INSTRUCTION TO SERVICE

ITS: 58416	
SECTION:	219 Engine and Transmission
WRITTEN BY:	Mike Pearson
SUBJECT:	Inspect all buses for correct O2 sensor seals and insulation installation

Figure 1: O₂ Sensor Blue Seal Locations

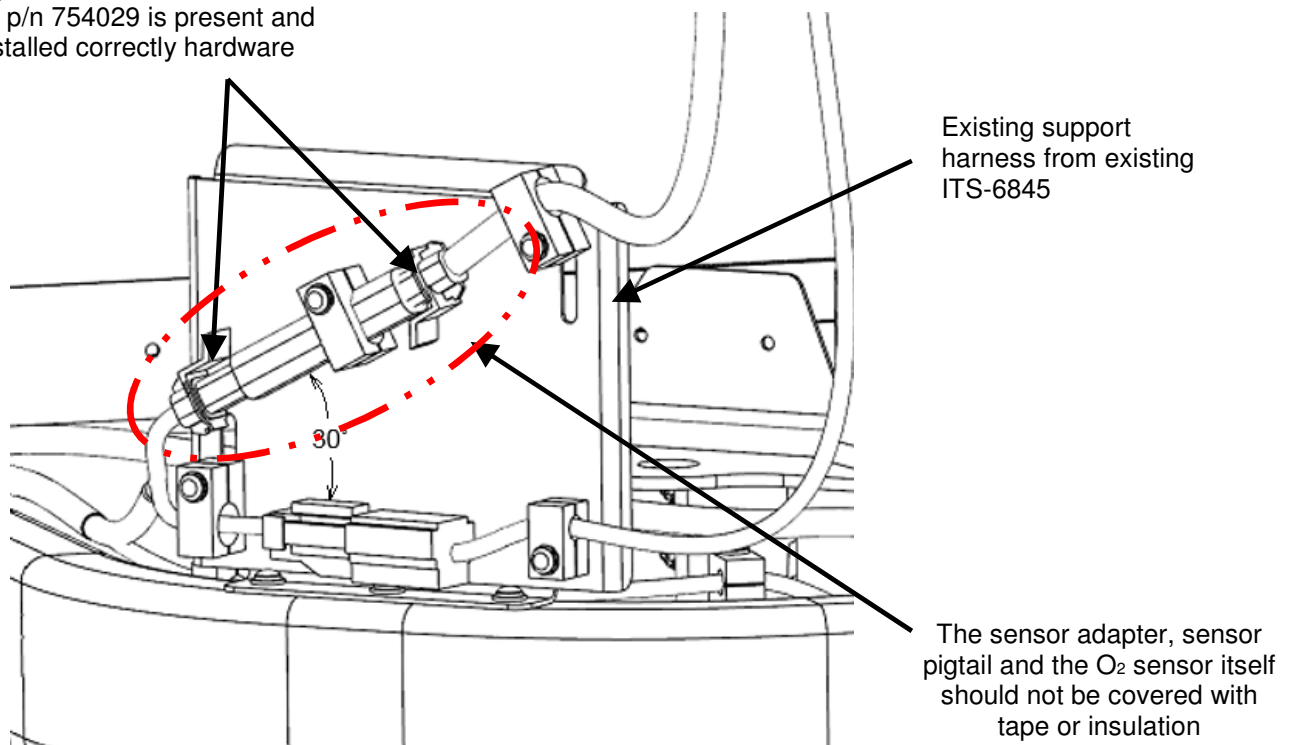
3. Examine the existing O₂ sensor for correct insulation installation, any existing high temperature tape or loom installed should not cover the sensor adapter, sensor pigtail or the O₂ sensor itself. If insulation or tape is present in these areas it must be removed.
4. Verify the correct blue connector seal p/n 754029 is present and installed correctly on the adapter that comes with the aftertreatment harness from Cummins, see figure 1.
5. Verify the correct blue connector seal p/n 754029 is present and installed correctly on the New Flyer side male type connector that connects to the Cummins O₂ sensor adapter, see figure 1.

Verify the correct blue connector seal p/n 754029 is present and installed correctly hardware
